ADDENDUM #3

Re: Harrisburg Area Community College
Central Administration – Wildwood Conference Center Renovations
Phase 2 - Demolition
Solicitation # RFB13-12

From: Eastern PCM, LLC
Construction Manager – HACC
645 N. 12th Street, Suite 200
Lemoyne, PA 17043

RD-13

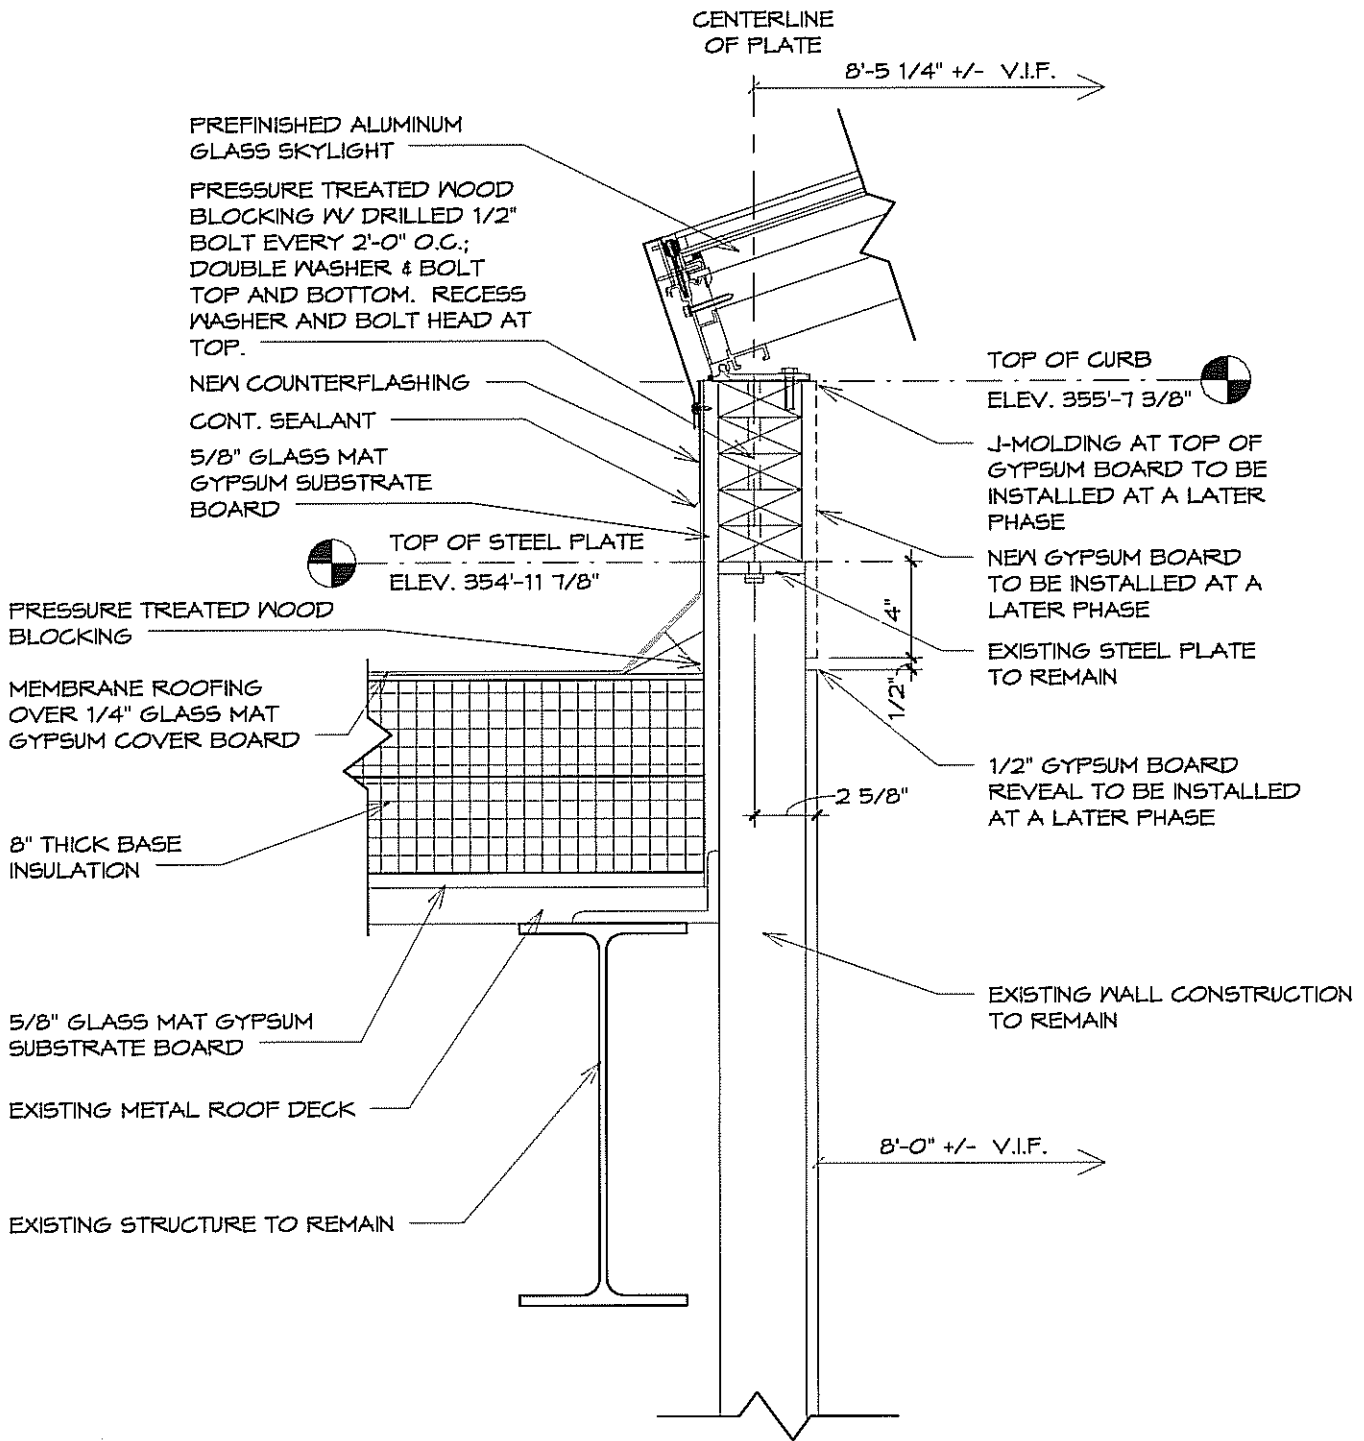
NOTE: SKYLIGHT SLOPE TO BE 4:12.
 APPLIES TO ALL SIDES OF SKYLIGHT.
 SEE DETAIL RD-21 FOR DIMENSIONS OF SKYLIGHT.

RD-14

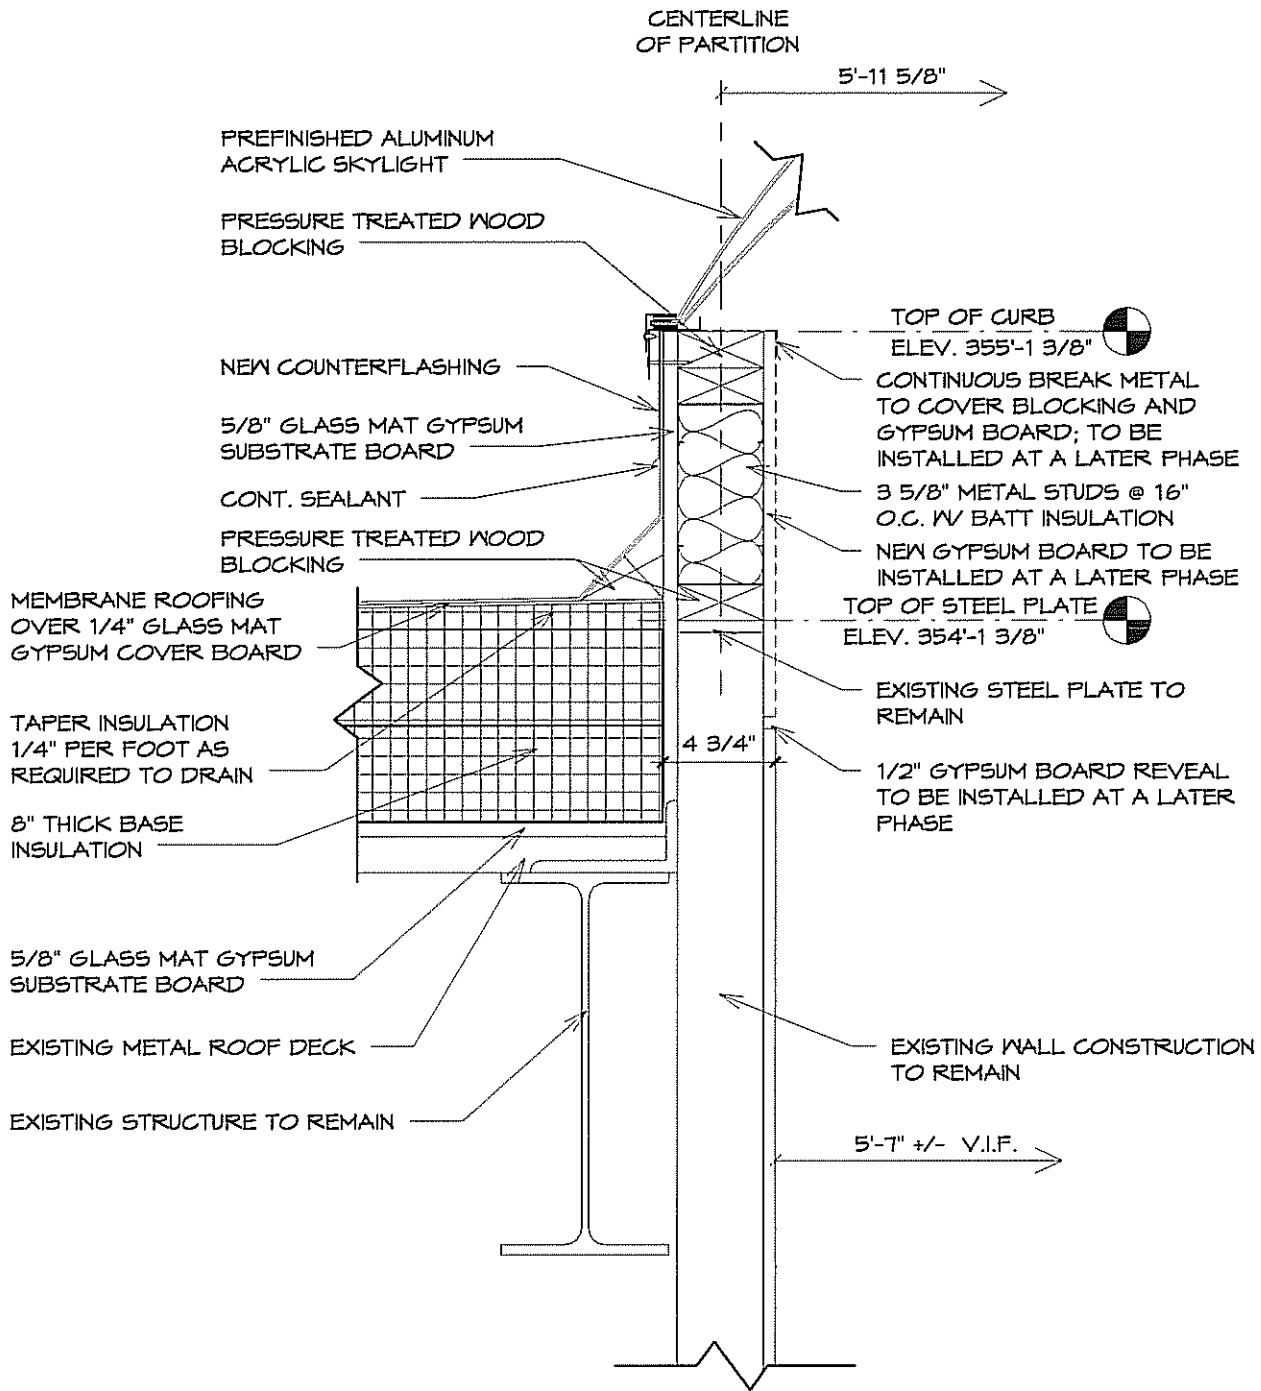
NOTE: SEE DETAIL RD-22 FOR DIMENSIONS OF SKYLIGHT.
